Response to Comments
on
Draft Permit Modification and Statement of Basis
for EPA's Proposed Remedial Action for the Housatonic River "Rest of River"
GE-Pittsfield/Housatonic River Site

U.S. Environmental Protection Agency
Region 1 (EPA New England)

October 2016

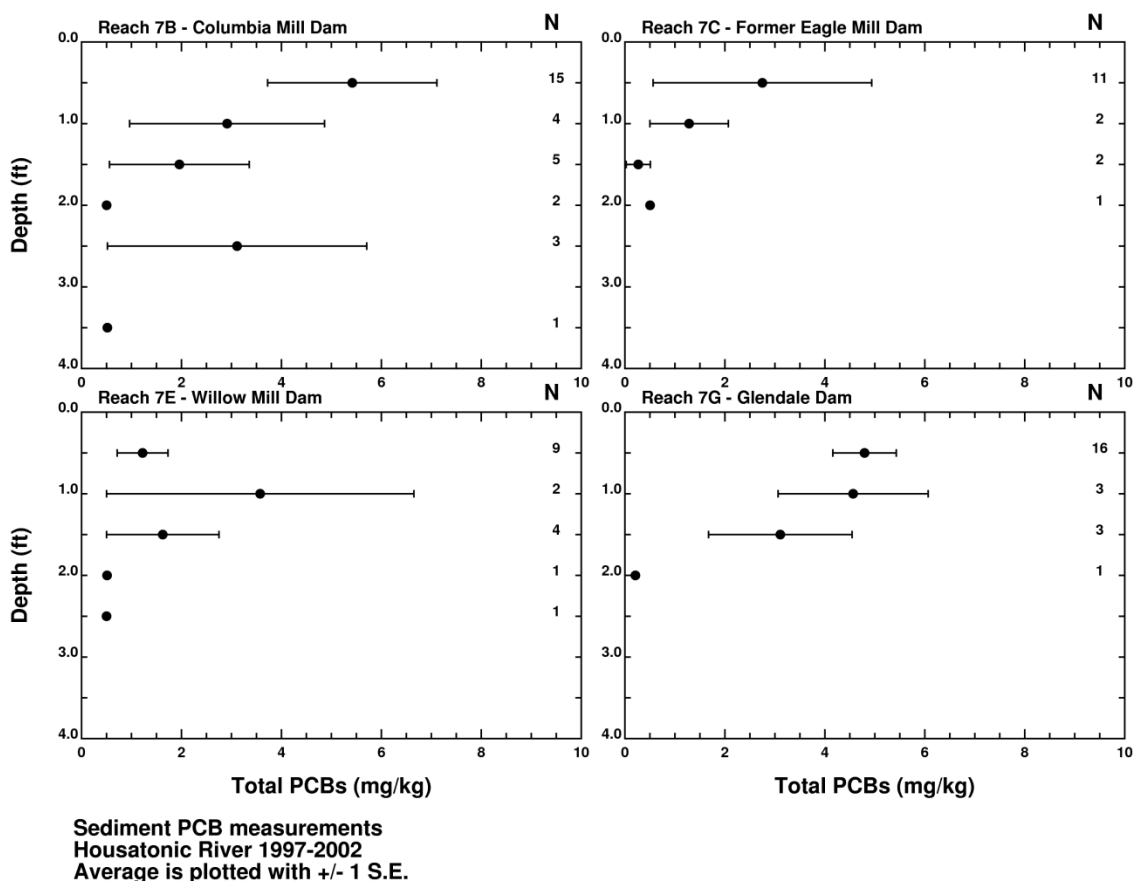
Comment 631: GE asserts the following: There is already considerable evidence of natural recovery in the Reach 7 impoundments, as indicated by a decline in PCB concentrations in fish, sediment, and water in the area; and that recovery will continue, given the recent and ongoing remediation efforts upstream of the Confluence and the anticipated remediation of the sediments in Reaches 5 and 6 (the only significant source to Reach 7), whether under the proposed remedy or a less intrusive but equally effective remedy, as illustrated by the model results. In addition, the Reach 7 impoundments are conducive to natural recovery, since expected human exposure is low and/or can be controlled by institutional controls, the impoundments are relatively quiescent and net depositional environments with a reasonably stable sediment bed and a low potential for scour, and sediment PCB concentrations are low compared to upstream areas and do not indicate the presence of “hot spots” (see [GE Attachment H]).

EPA Response 631: GE claimed in the comment that declining PCB concentrations in the sediment of Reach 7 Impoundments indicate that natural recovery is occurring there; however, no evidence is included in the comment to support the assertion and EPA does not believe that the claim of natural recovery can be supported with existing data. Analyses conducted by GE using data from Impoundments upstream and downstream of Reach 7 [i.e., Woods Pond and Rising Pond (RCRA Facility Investigation Report (RFI), GE, 2003)] do not support this assertion. In Section 4.6 of the RFI, GE concludes that the best fit approach results in a slope indicating a downward trend in PCB concentration in sediments. Further, GE concludes that:

Although slight downward slopes are computed in the regression analysis plotted in Figure 4-25, the relatively high p-values (all greater than a 95% significance level of 0.05) indicated that the downward slopes are not statistically significant. The results of this trend analysis should be interpreted with caution due to the limited data and high variability within the range of samples years. Indeed the

low r^2 values (all less than or equal to 0.1) shown on Figure 4-25 illustrate the importance of caution in interpreting these results, as the simple model of exponential decline over time explains less than 10% of the variability in surface PCB concentrations in these impoundments.
